## IMMINGHAM EASTERN RO-RO TERMINAL DCO APPLICATION

### PINS REFERENCE TR030007

#### COMMENTS ON DEADLINE 5 SUBMISSIONS BY DFDS

Figure 1 - East Gate Configuration

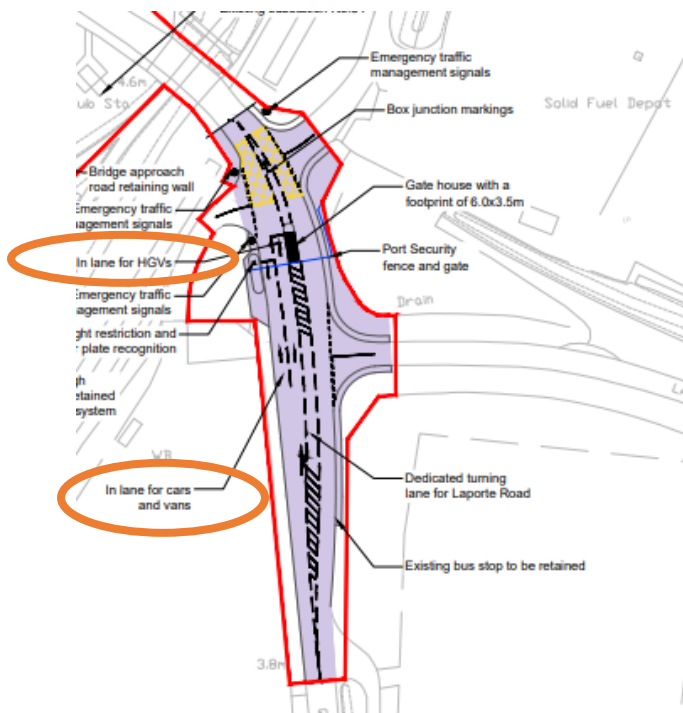
51. The assessment of the East Gate considers that both lanes on the East Gate can be used to enter the port, however details shown on the General Arrangement Plans East Gate & Bridge Regulation 5(2)(o) & 5(2)(k) Sheet 3 of 5 [[AS-029](#)] show that the left hand land is dedicated to cars and vans, whilst the right hand lane is dedicated to HGV's (a screen shot of this is provided in Figure 1 - East Gate Configuration). This would mean that queue capacity for HGV is significantly over represented within the gate house assessment.

52. The Applicant's Transport Consultant indicates that this is not correct and the design will be modified in detail design, however this is contradictory to what is stated in the project drawings.

Figure 2 - Areas and Location of Local Facilities

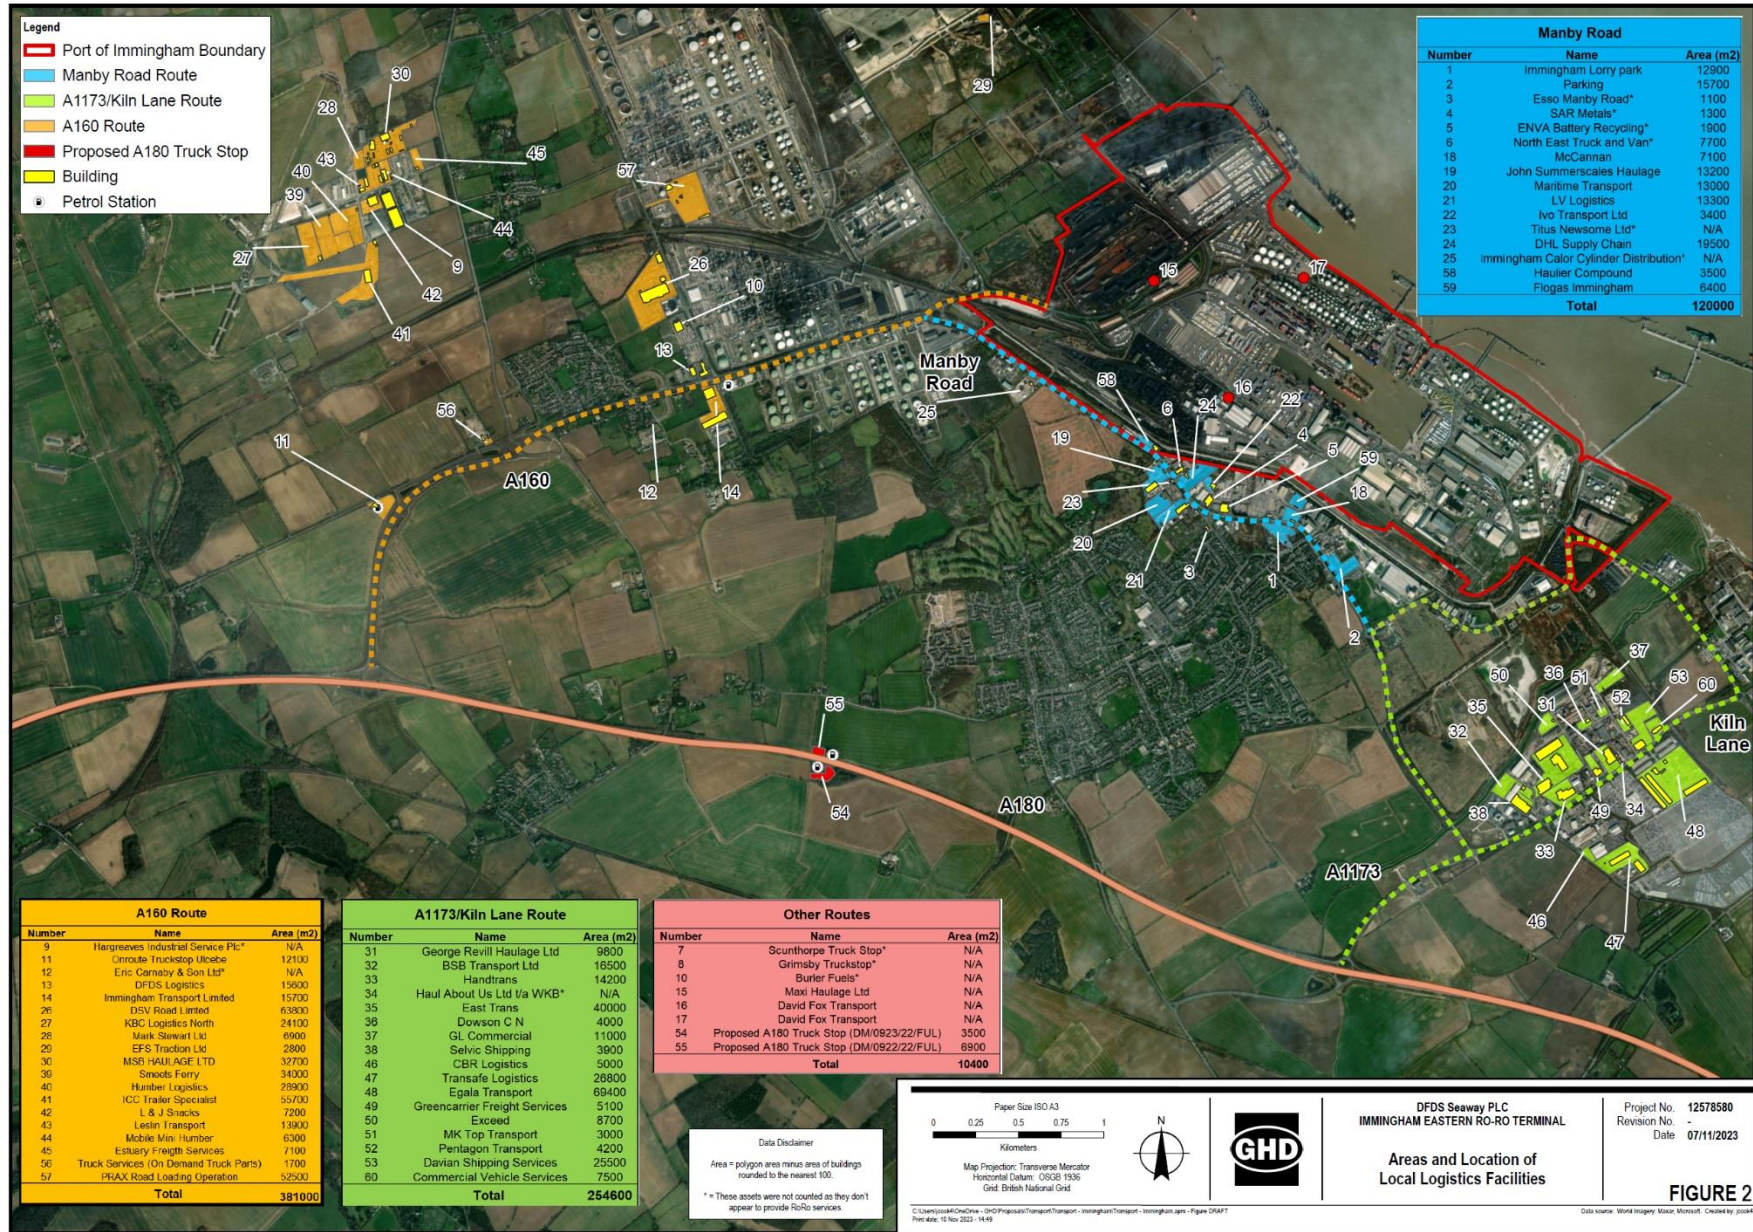
63. To improve this assessment DFDS have produced a Figure (provided below) which sets out the locations of, and access routes to, local haulier facilities which indicates that 60% of local traffic routes via the A160 and 40% of local traffic routes through the A1173, based upon the distribution of hardstanding accessed from each route (381,000 sqm via the A160 and 254,600 sqm via the A1173).

64. This has been discussed with DTA within the Transport Working Group forum and is considered to provide a reasonable evidence base upon which sensitivity testing should be undertaken.

65. Figure 2 supersedes the information presented within section 2 of Annex B of [REP5-027](#).

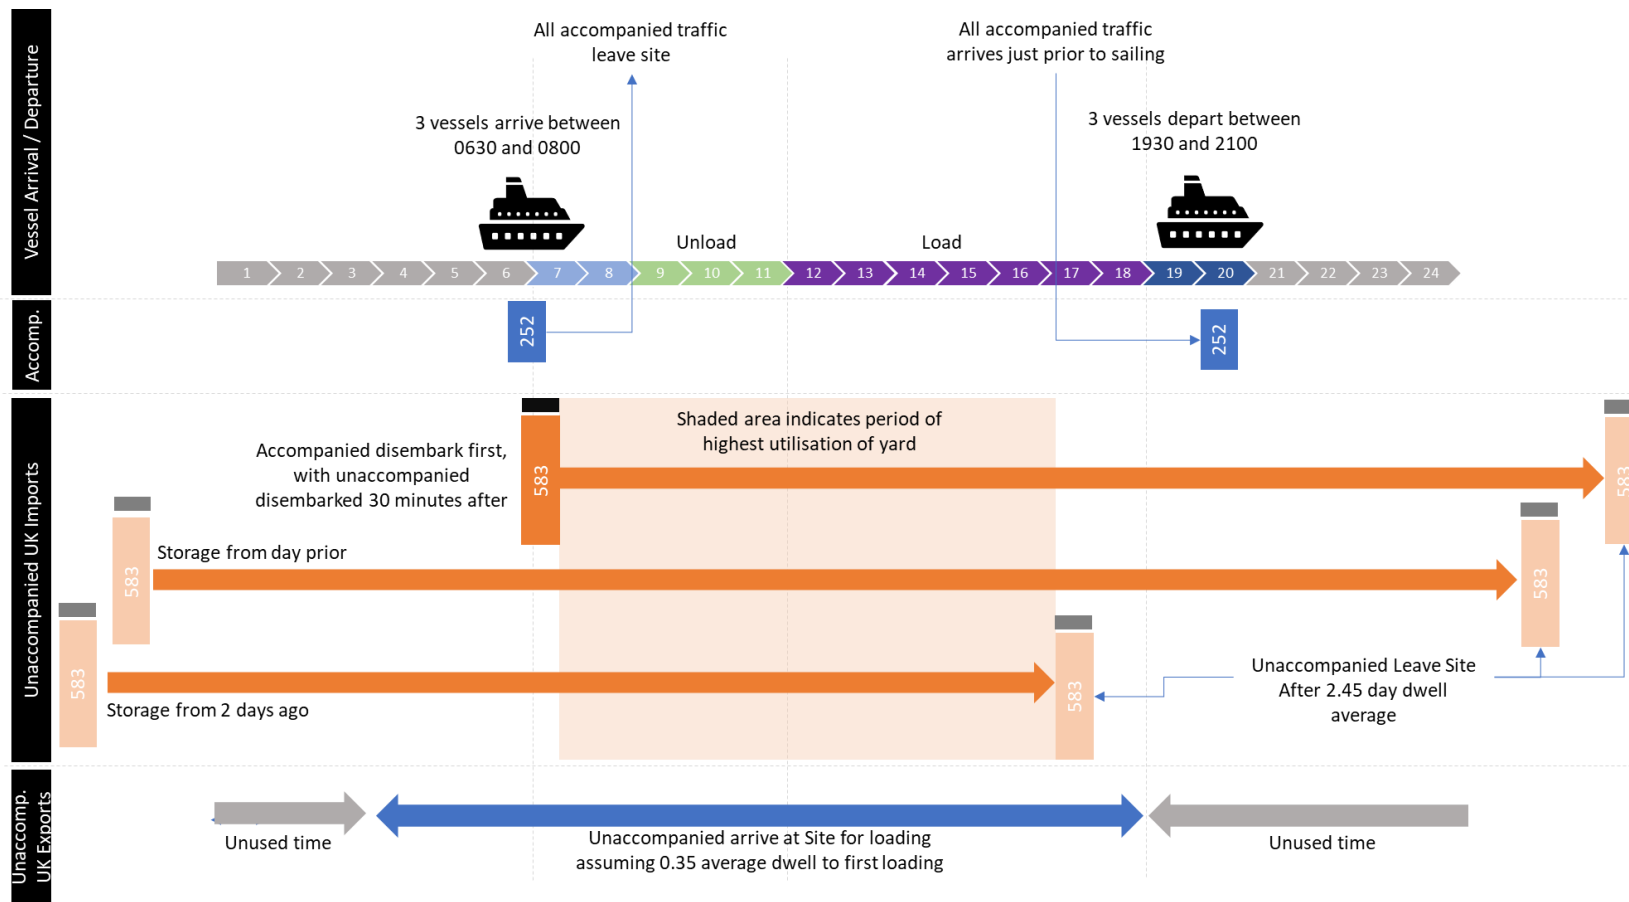
106. The Applicant has indicated that a 0.35-day (approximately 8.5 hour) dwell rate for UK unaccompanied exports is anticipated for the IERRT operations. This implies that the Applicant intends to 'cycle' the slots within the yard around three times per day (i.e. each import slot is used on average 3 times during the course of the day). This is based on a 24-hour operating window, which as described above, doesn't exist in practice for this facility.

107. If the 0.35 day dwell rate is accurate, at least 50% of the units would need to be at the terminal awaiting loading 8.5 hours prior to departure. Given that loading of the vessel is not available until around this time, that mean around 250 to 280 units would be waiting in the yard. This exceeds the 228 slots provided in Appendix 4 [\[REP5-032\]](#).

108. In effect, the time to complete these three cycles is actually 11.5 to 14.5 hours based on the above loading window (150% of the 7.5 to 9.5 loading time). From DFDS operational experience, this is significantly constrained and would lead to operational complexities within the yard.

Figure 3 - Peak Operations - UK Import Slot Requirements

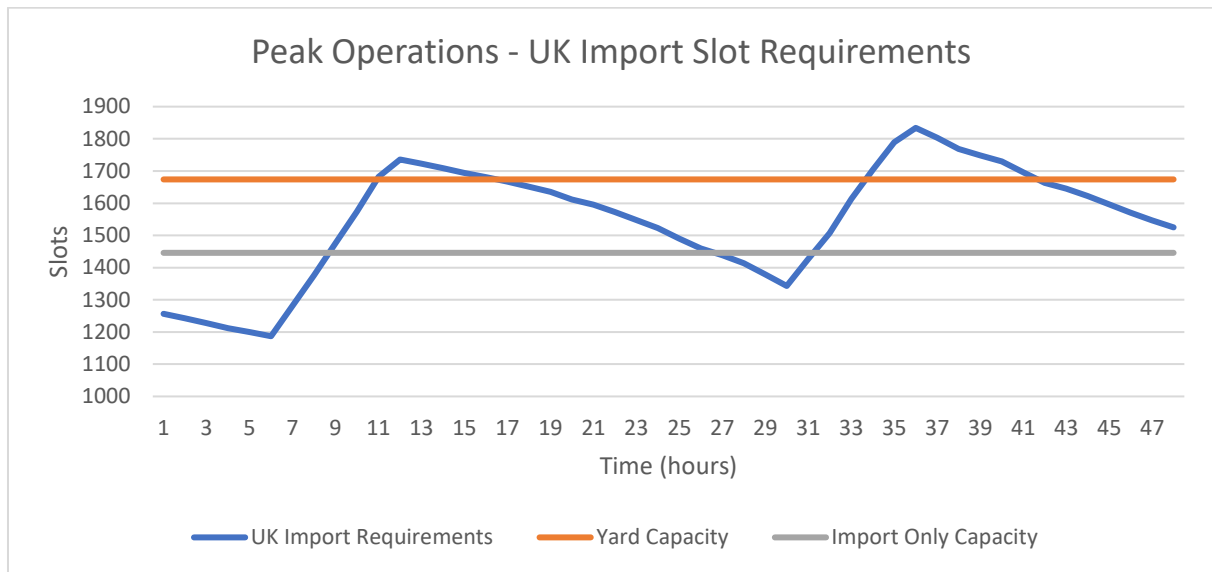
112. This is noted as a the normal, or business as usual operating condition. To assess the yard capacity of UK Imports only (i.e. excluding UK Exports), DFDS have prepared a dynamic simulation model. The model randomly generates fluctuations of daily levels within a lower limit (1,440 units per day), and an upper limit (1,813 units per day), and randomly generates dwell rates between 1.5 to 3 days, centred around 2.45 days average, with calculations done at an hourly level. This model indicates that the yard would need the following number of slots available for UK imports only during the overlap period:

- a. Peak operations: 1,700 to 1,800 slots – which exceeds the capacity of the yard (presented in Figure 3)
- b. Normal operations: 1,500 slots. Given the applicants intent to run the facility at 80% utilisation during normal operations, this leaves the number of slots occupied by UK Imports exceeding their operating targets by circa 100 units and providing no capacity for UK Exports.

113. Therefore under peak operations, the yard will exceed capacity for UK Imports alone. And under normal operations, the import operations will still exceed operating targets, albeit within the capacity of the site, however without consideration for UK Exports. For normal conditions, the yard would need to be meticulously managed, with full control over vessel arrivals, haulier arrivals, tug units within the yard, unloading processes, and movement of accompanied units within the terminal. All of which is practically unachievable for the intended throughputs identified.
